ATTACHMENT 2

DETAILED ASSESSMENT

The overall site which is the subject of this Planning Proposal involves:

Figure 1 - Extended CBD boundary

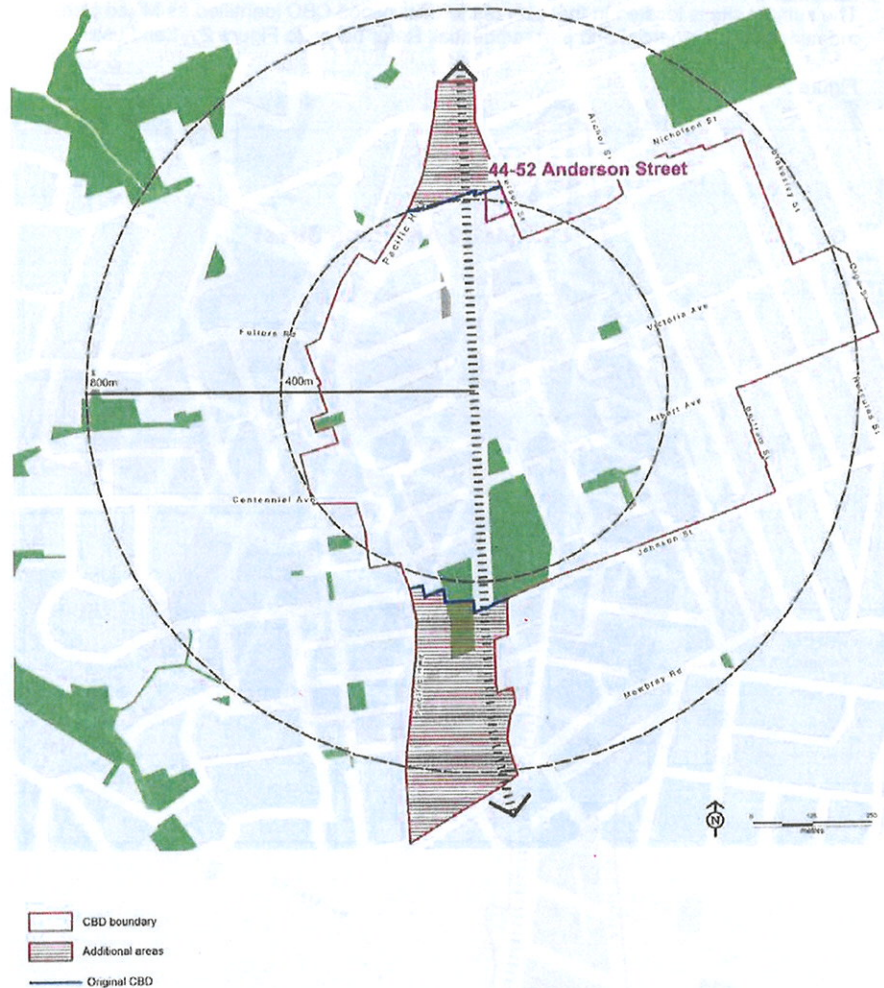
The subject site is located within the existing and the expanded Chatswood CBD boundary proposed in the CBD Strategy, as shown below in Figure 1.

Figure 2 – Land use

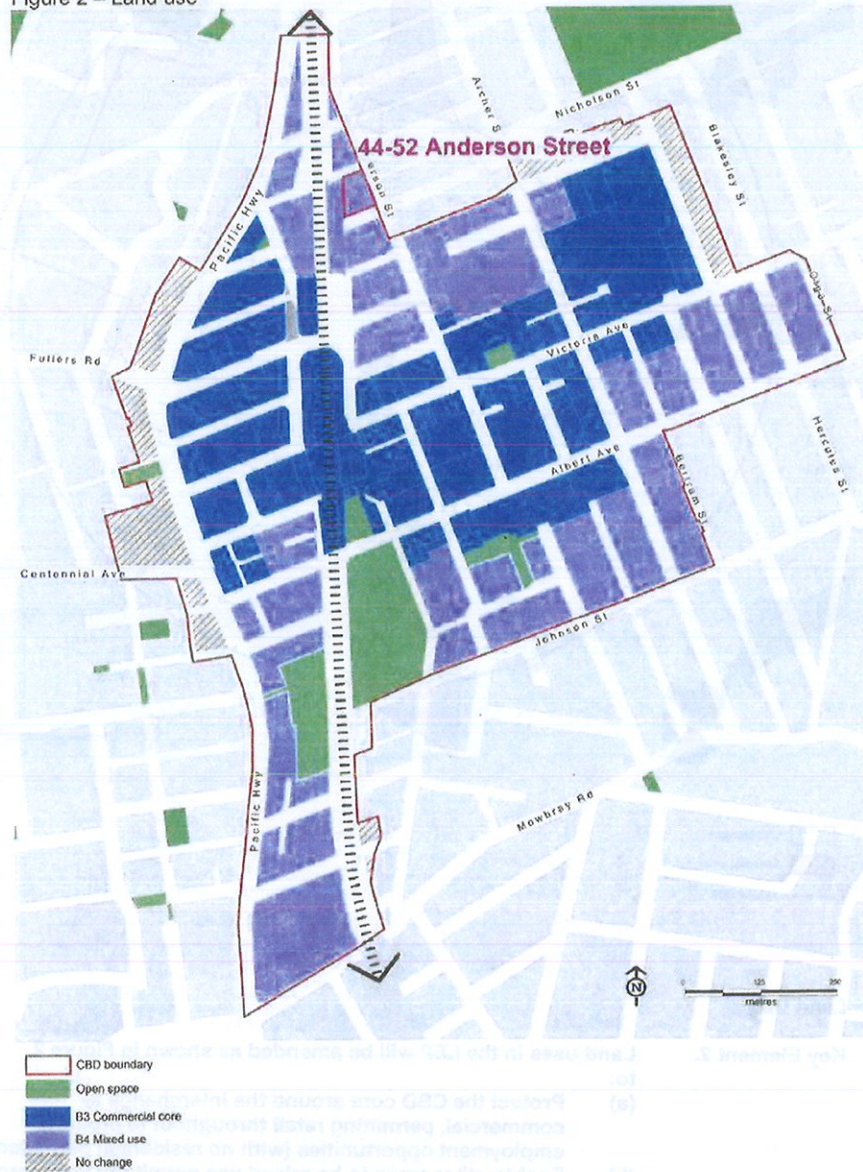
The subject site is located in that part of the Chatswood CBD identified as Mixed Use, meaning part commercial and part residential. Refer below to Figure 2 – Land use.

The proponent has proposed the zoning for the site be changed from R3 medium Density Residential to B4 Mixed Use which is consistent with the CBD Strategy.

Figure 3 – Existing FSR under WLEP 2012

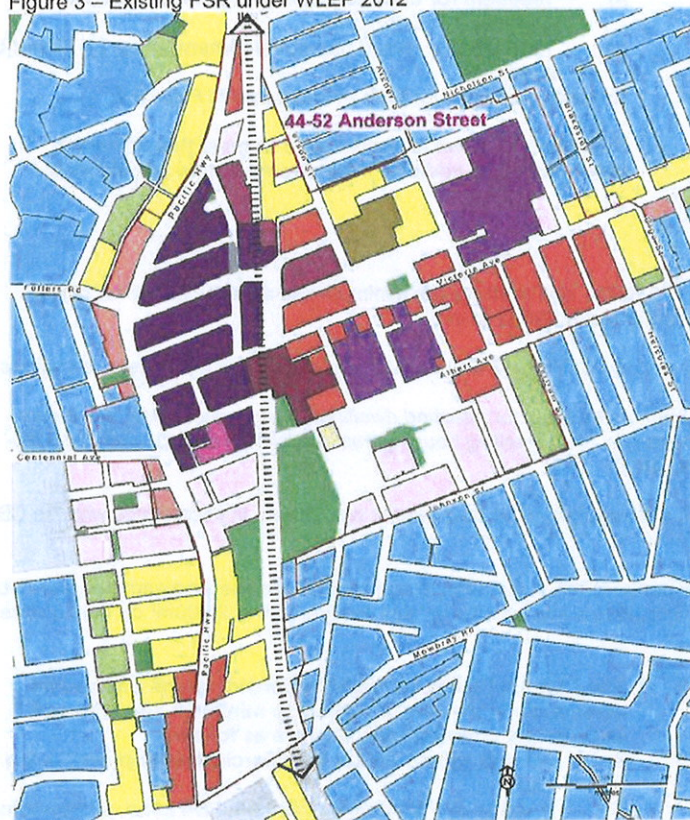
The subject site is in a location with a maximum floor space ratio of 0.9:1 as shown below in Figure 3 – Existing FSR under WLEP 2012.

The Planning proposal seeks to increase this to 6:1, which is discussed below in Key Element 12.

Figure 4 - Maximum Floor Space Ratio

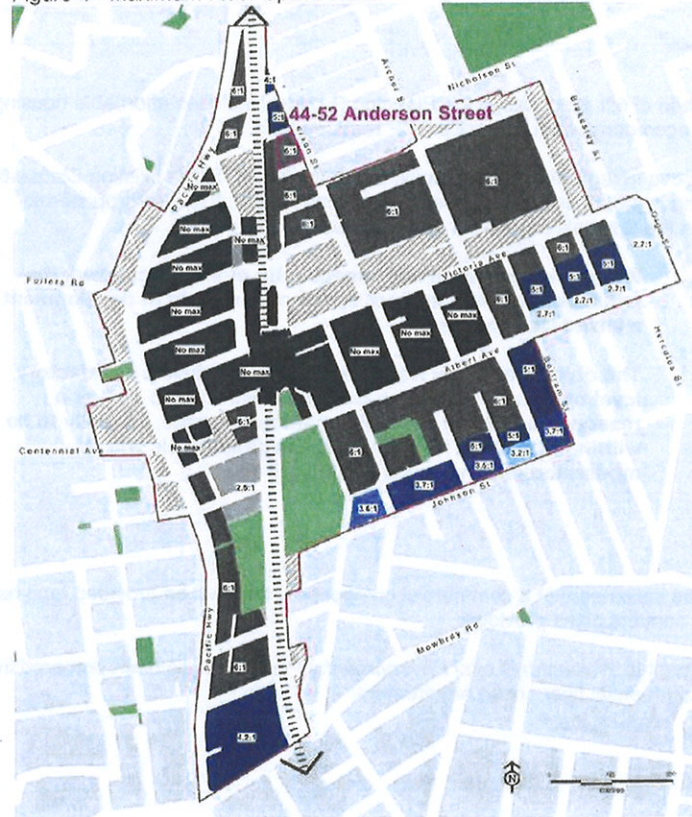
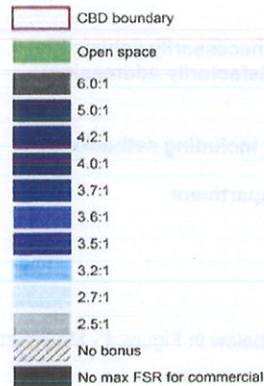
The subject site is in a location with an FSR of 6:1, as shown below in Figure 4 - Maximum Floor Space Ratio.

The Planning Proposal proposes a maximum FSR of 6:1, which includes affordable housing, and is therefore consistent with the CBD Strategy.

Figure 6 – Height

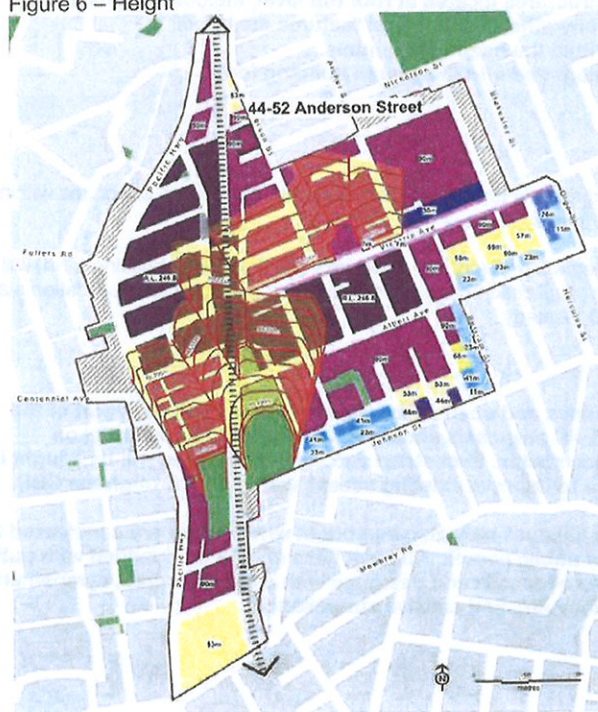
As a result of the site location, the maximum height of 90 metres is able to be achieved on the subject site.

The maximum height requested includes provision for affordable housing as well as lift over runs and roof plant rooms.

Figure 7 - Links and New Open Space

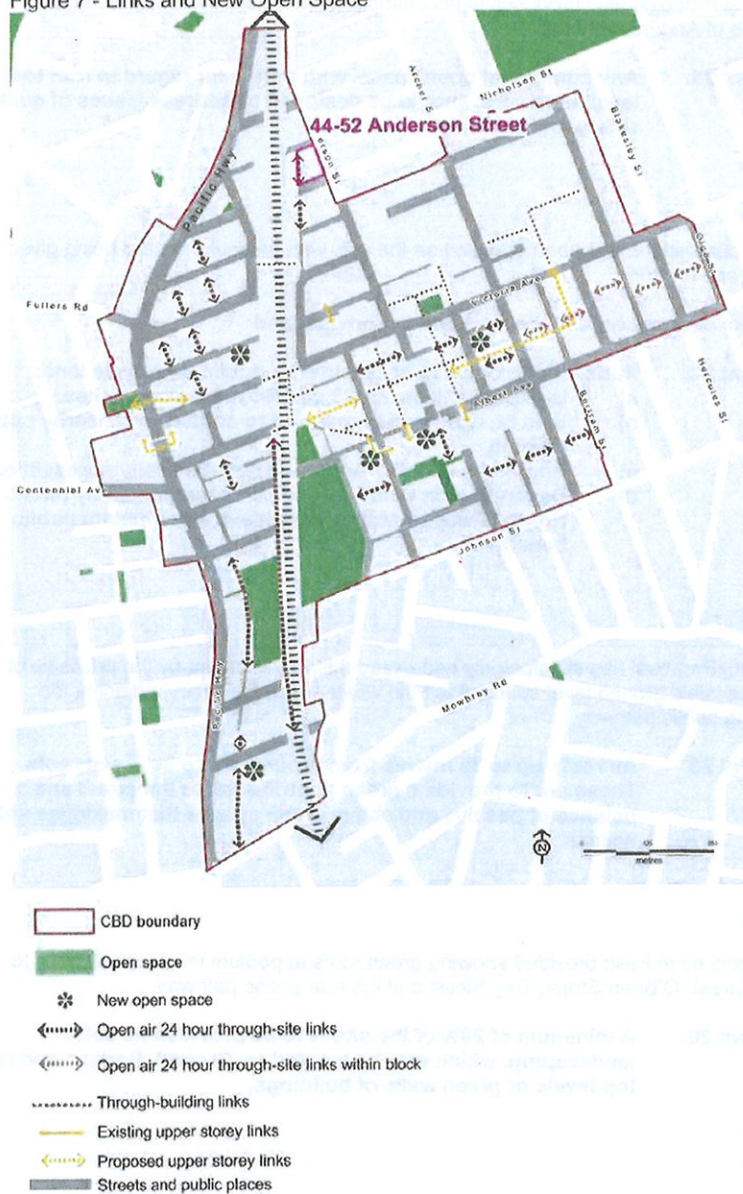
The site is adjacent to an identified open air 24 hour pedestrian link, as shown below in Figure 7 - Links and Open Space – at the rear or western boundary of the site adjacent the existing public pathway.

The Planning Proposal proposes to embellish the existing pedestrian link (public pathway) by providing a publicly accessible (via a right of way) 2m landscaped area along the western boundary of 44-52 Anderson Street - adjacent the public pathway.

Figure 8 - Setbacks and street frontage heights

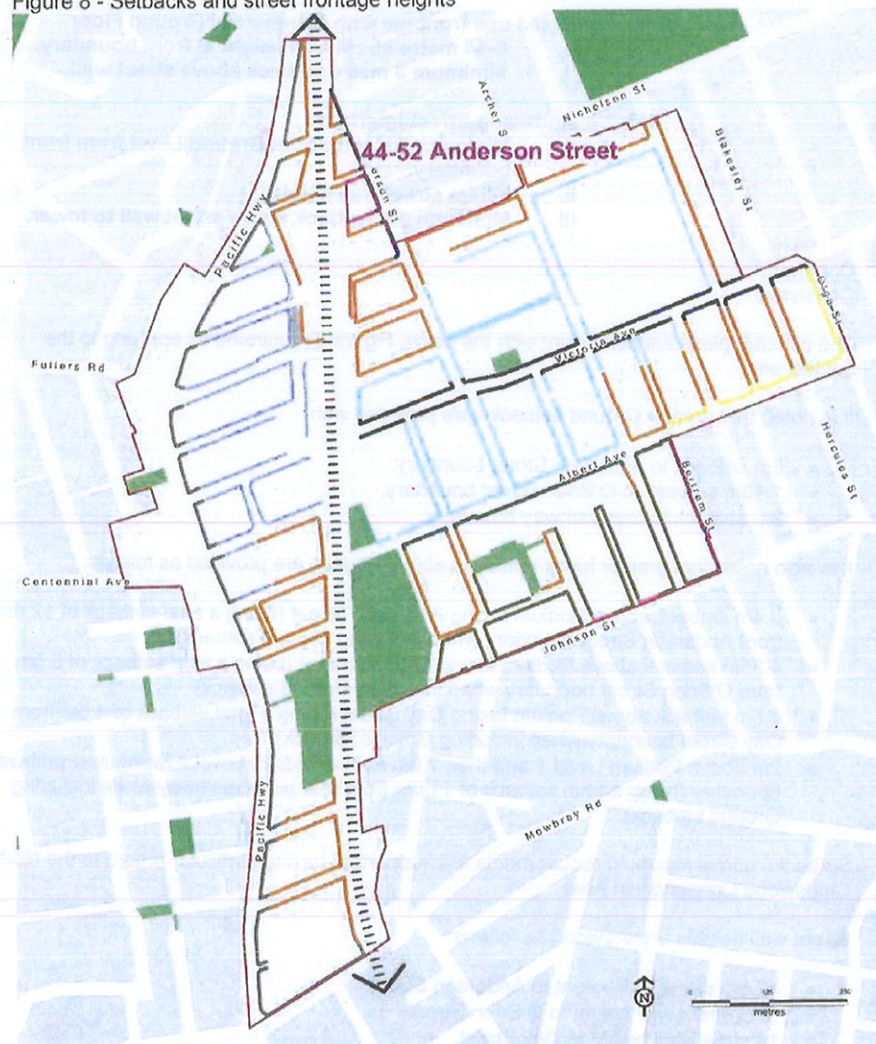
The concept plans are consistent with the below Figure 8 requirements applying to the subject site.

Setbacks above minimum requirements are supported, having particular regard to the North Chatswood Conservation Area.

- 12.5m street wall height to Anderson Street.
- 10m street wall height to O'Brien Street.
- 14 street wall height to Day Street.
- 14m street wall height to rear pathway – noting that this is a sloping boundary so the majority of the wall is much less, and the street wall is broken by the First Level being setback 2m.

Street wall heights below the maximum requirements with particular regard to Anderson Street and O'Brien Street (and the North Chatswood Conservation Area interface), as well as the public pathway to the rear, are supported.
